GAINES CHARTER TOWNSHIP
PLANNING COMMISSION – REGULAR MEETING
Township Board Room - 8555 Kalamazoo Ave. S.E. Caledonia, MI 49316

Tentative Agenda

7:00 p.m. – Thursday, October 26th, 2023

**DRAFT MINUTES OF THE GAINES CHARTER TOWNSHIP PLANNING COMMISSION REGULAR
MEETING
HELD ON SEPTEMBER 28th, 2023**

Pine Rest Proposed Access Location on 72nd Street

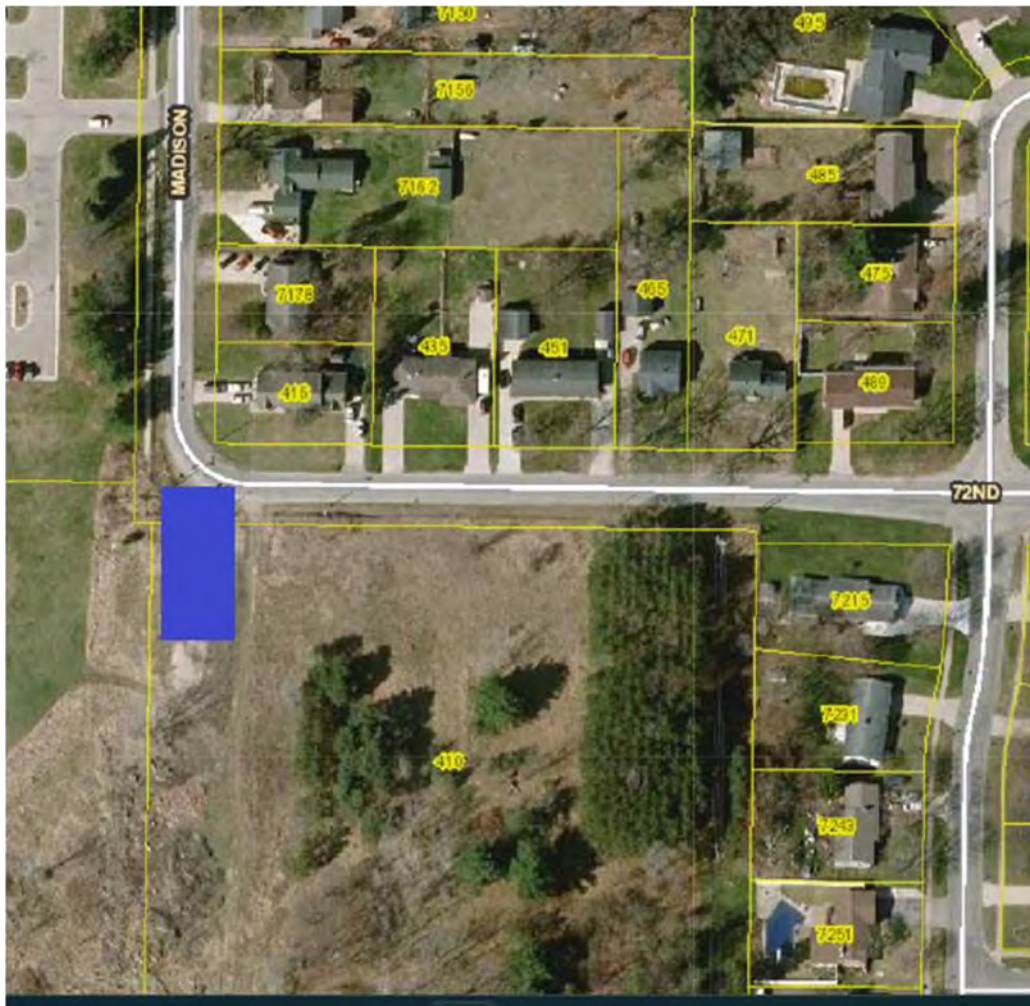
The proposed road location lines up with the front of the existing duplex at 451 and 453 72nd Street. The picture below shows where the alignment of the proposed road will look toward the duplex.

- The proposed road location conflicts with **Gaines Township's Zoning Ordinance, 25.6F. Privacy:** The site design must provide reasonable visual and sound screening and privacy for dwelling units on the site and adjacent properties using fences, buffers, berms, and other measures, as appropriate.
 - The proposed Health Center is a 24/7 operation which leads to vehicular traffic at all times. At the proposed road location this will have an unreasonable impact on privacy for the existing duplex.
 - Vehicles leaving the site will cause headlights to shine on the duplex at all hours of the night.

**ELECTRICAL SITE PLAN -
PHOTOMETRICS**

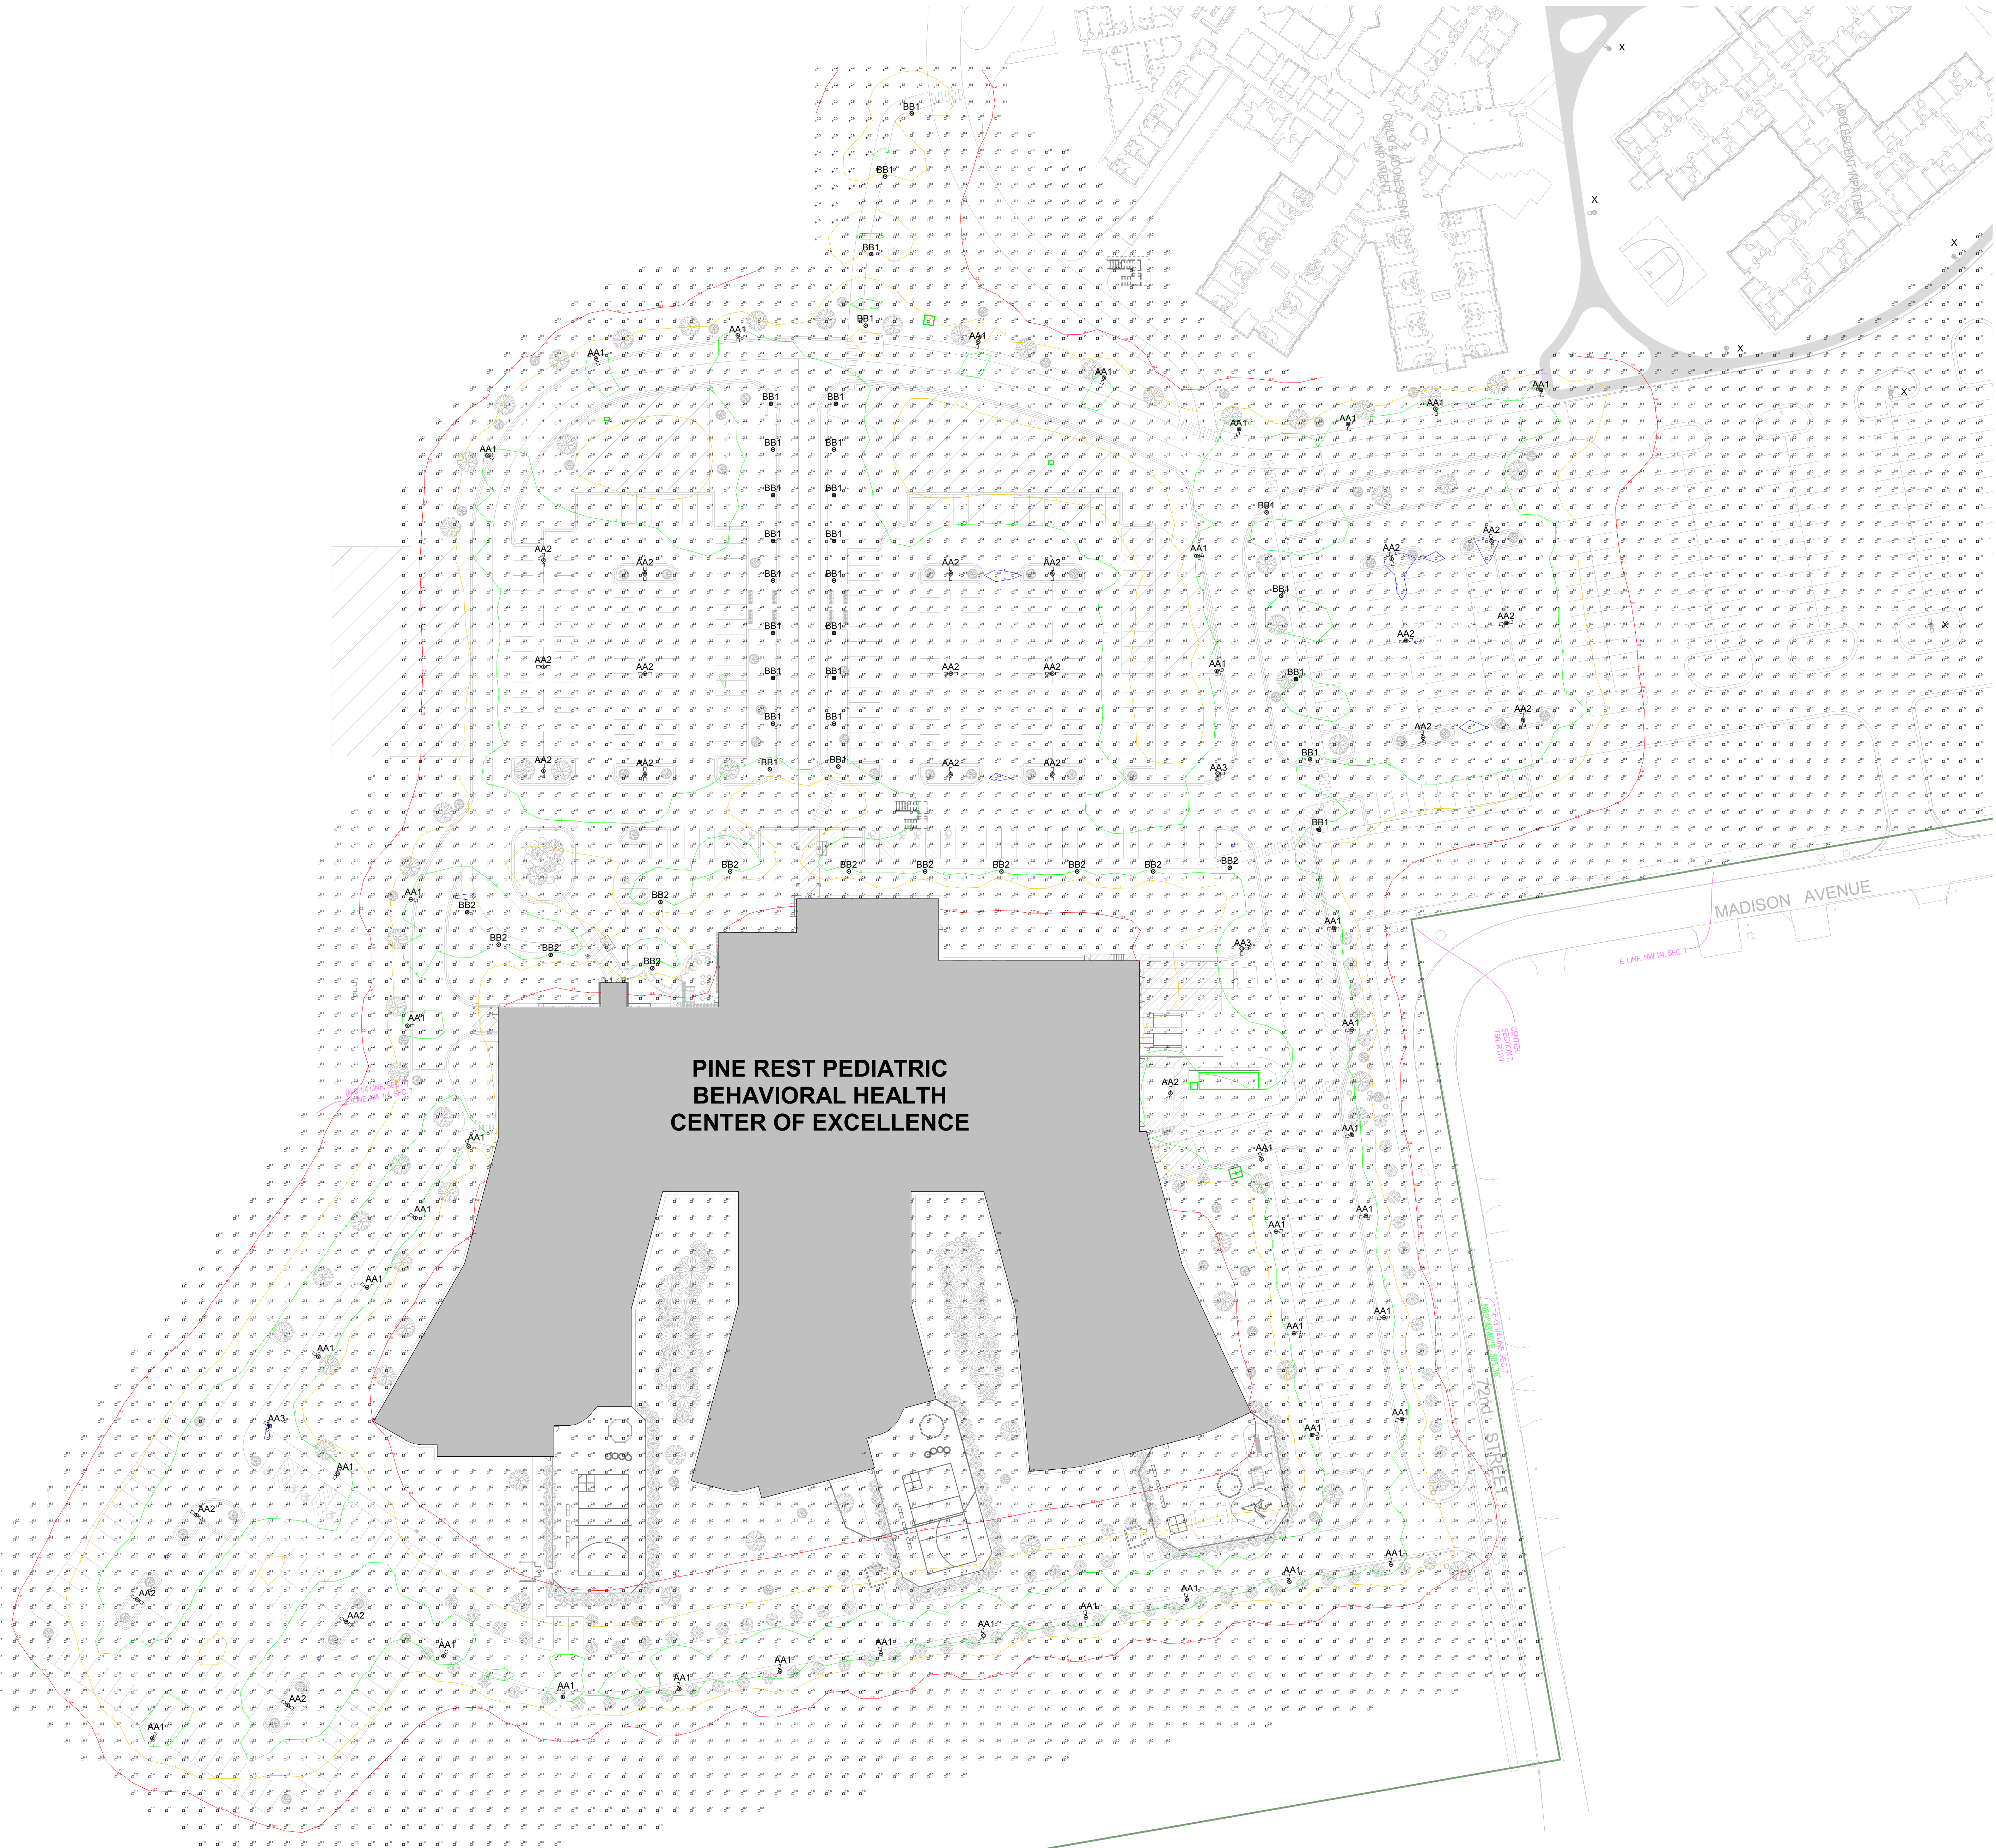
Planner Wells explained that two monument signs are shown on the site plan, but only one will be permitted per the zoning ordinance. The lighting data sheets provided indicate LED temperatures at 4000K; staff recommends using soft white lights in the 3000K – 3500K range to reduce the negative effects of bright white light on neighboring properties. Wells stated that more evergreen trees should be planted along the eastern periphery to buffer the building from the adjacent neighborhood on Sundale Drive. Wells suggested that the Planning Commission give staff the authority to review a revised landscaping plan once the changes are made and if the project is approved. Overall, Staff has recommended approval of the project with the conditions listed in the staff report.

- The site lighting plan was revised to change the light temperature color from 4000k to 3500k.
- The existing fence on the east property line will be removed and a new fence installed. This is shown and labeled on the site layout plan (sheet 201.CS and the landscape plan)
